DC Cook Unit 2 Containment Backpressure Comparison

Change Description: **UCR-1974, Rev. 0**

Title: **D.C. Cook Unit 2**
Lower Bound Containment Pressure

UFSAR Figure: **14.3.1-3**

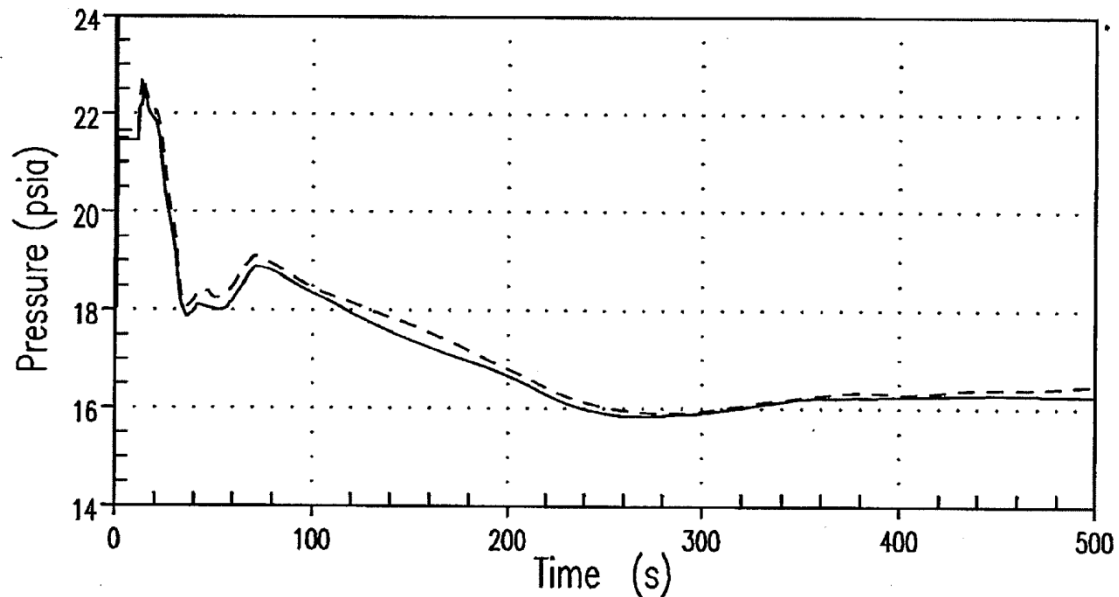
1. Due to errors identified with the LOTIC2 containment backpressure calculation, an evaluation was performed assuming a revised initial CTS temperature. See Section 14.3.1.5 for more information.
